Work Order ID 141874

Item Name: Baggage Compartment Protector - Floor And Wall

DART SERVICE INSTRUCTION

TO AMEND INSTALLATION INSTRUCTIONS IIN-D407-781-2 REV. A OR LATER APPROVED REVISION
AND INSTRUCTIONS FOR CONTINUED AIRWORTHINESS ICA-D407-781 REV. 3 OR LATER REVISION

**FIGURE 1 - D3879-1 BAGGAGE COMPARTMENT WALL
PROTECTOR - ALTERNATE INSTALLATION**

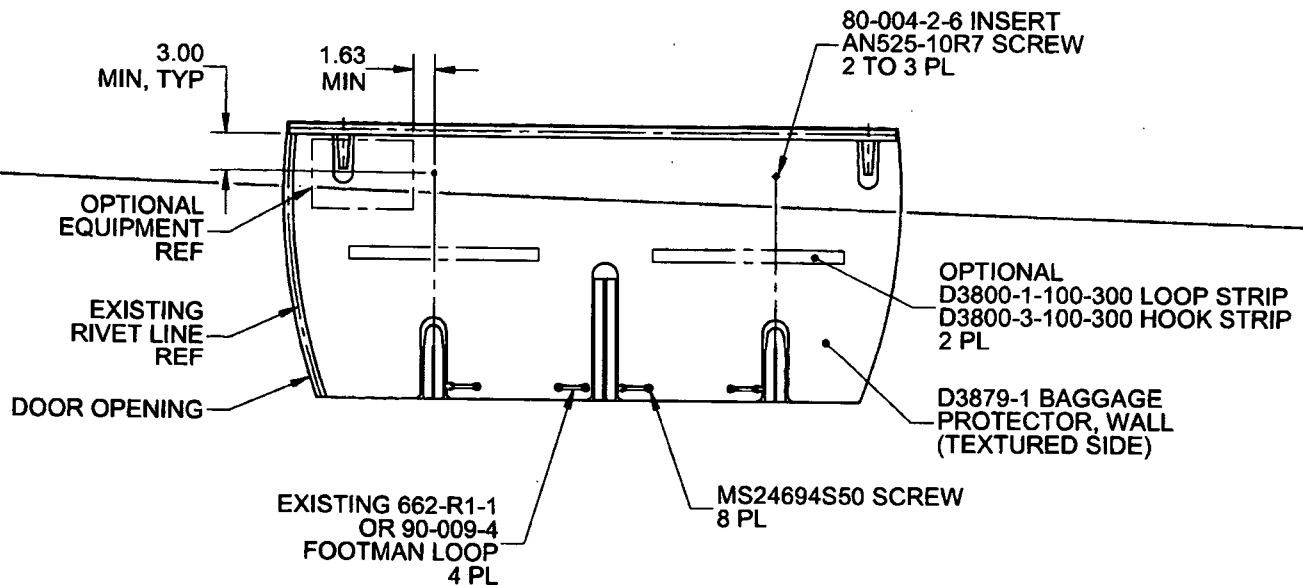
In some aircraft, the top portion of the D206-781-041 Baggage Compartment Wall Protector Kit cannot be installed as indicated in IIN-D407-781-2. The purpose of this DSI is to provide an alternate mounting method to fasten the top portion of the D206-781-041 Baggage Compartment Wall Protector Kit.

It is acceptable to replace qty(2) D3930-1 Clips with qty(2) 80-004-2-6 Inserts. Locate and mark location of the two attachment holes on the baggage compartment wall as shown in Figure 1 of this service instruction. Install 80-004-2-6 Inserts at the marked locations in accordance with Section 3-2-12 of BHT-206-SRM-1. It is acceptable to trim the wall protectors to accommodate optional equipment or transfer attachment holes to the wall protector and install the optional equipment on top of the wall protector with longer fasteners.

Amend the D206-781-041 Baggage Compartment Wall Protector Kit parts list as follows:

Qty -061	Qty -031	Qty -041	Part Number	Description
X			D206-781-061	BAGGAGE COMPARTMENT PROTECTOR KIT (FLOOR AND WALL)
1	X		D206-781-031	BAGGAGE COMPARTMENT FLOOR PROTECTOR KIT
1		X	D206-781-041	BAGGAGE COMPARTMENT WALL PROTECTOR KIT
		2	AN525-10R7	SCREW
		2	80-004-2-6	INSERT
